Validation Report

Report for:
Delhi Metro Rail Corporation Limited (DMRC)

Validation of CDM PoA for The MRTS PoA

LRQA Reference	: CDM-MUM-0061935 Version 04.7
Date	: 14/11/2014
Work carried out by	: Archak Pattanaik Ankush Jain Arnab Deb Aditi Dass
Work verified by	: Imran Ustad Prabodha C Acharya Pritha Ghosh Chatterjee Michiaki Chiba

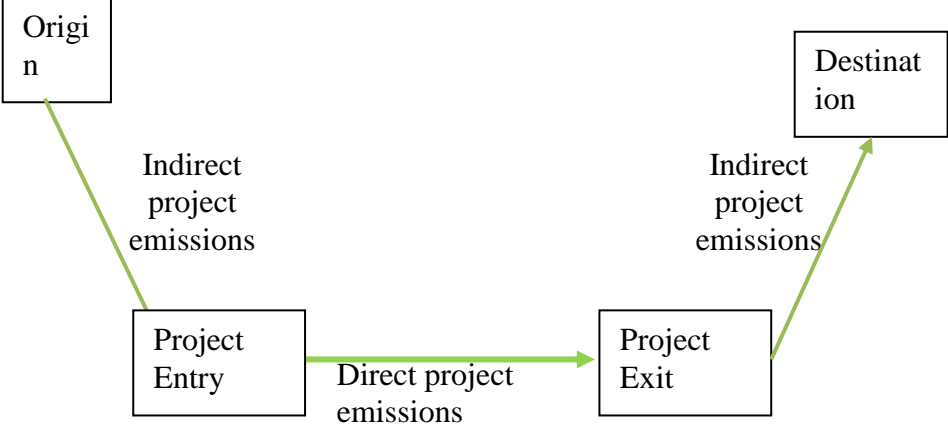
Validated situation	Conclusion
	<p>as leakage. The emission factor per PKM is calculated as follows:</p> <p><i>Emission factor per PKM for electricity-based transport systems (Existing metro rail):</i></p> $EF_{PKM,i,y} = \frac{TE_{EL,i,y}}{P_{EL,i,y} \cdot TD_{EL,i}} \times 10^6$ <p>Where:</p> <p>$EF_{PKM,i,y}$ Emission factor per passenger-kilometre for electricity-based vehicle category i for year y (gCO₂/PKM)</p> <p>$TE_{EL,i,y}$ Total emissions from the electricity-based vehicle category i for year y (tCO₂)</p> <p>$P_{EL,i,y}$ Total passengers transported per year by the electricity-based vehicle category i for year y (passengers)</p> <p>$TD_{EL,i}$ Average trip distance travelled by passengers using the electricity-based vehicle category i prior to project start (km)</p> <p>The total emissions from the existing metro rail category i, $TE_{EL,i,y}$, is calculated, using the 'Tool to calculate baseline, project and/or leakage emissions from electricity consumption'. When applying the tool, the parameter $EC_{BL,k,y}$ in the is taken as the amount of electricity used by the electricity-based vehicle category i for year y, consistent with the transportation of $PE_{L,i,y}$ passengers along the average distance $TD_{EL,i}$.</p> <p>For fuel-based vehicle categories identified above (bus/taxi/passenger car/Auto rickshaw/motorcycle), the emission factor per PKM is calculated as follows:</p>

Validated situation	Conclusion
	$EF_{PKM,i,y} = \frac{EF_{KM,i,y}}{OC_i}$ <p>Where:</p> <p>$EF_{PKM,i,y}$ Emission factor per passenger-kilometre of vehicle category i in year y (gCO₂/PKM)</p> <p>$EF_{KM,i,y}$ Emission factor per kilometre of vehicle category i in year y (gCO₂/km)</p> <p>OC_i Average occupation rate of vehicle category i prior to the project start (passengers)</p> <p>i Relevant vehicle category</p> <p>y Year of the crediting period</p> <p><i>Determination of the average occupation rate (OC_i)</i></p> <p>The average occupation rate of vehicle category i were determined based on visual occupation study for all vehicle categories i. In the case of taxis and auto rickshaws, the driver is not included in the study.</p> <p>The occupation studies have been conducted as per the guidance provided under Annex 1, and 3 of the methodology. For buses, the occupation rate is based on an average trip distance of bus passengers, total passengers and total distance driven by buses, using the following equation:</p> $OC_B = \frac{PBL_B \cdot TDBL_{P,B}}{DD_B}$ <p>Where:</p> <p>OC_B Average occupation rate of buses prior to the project start (passengers)</p>
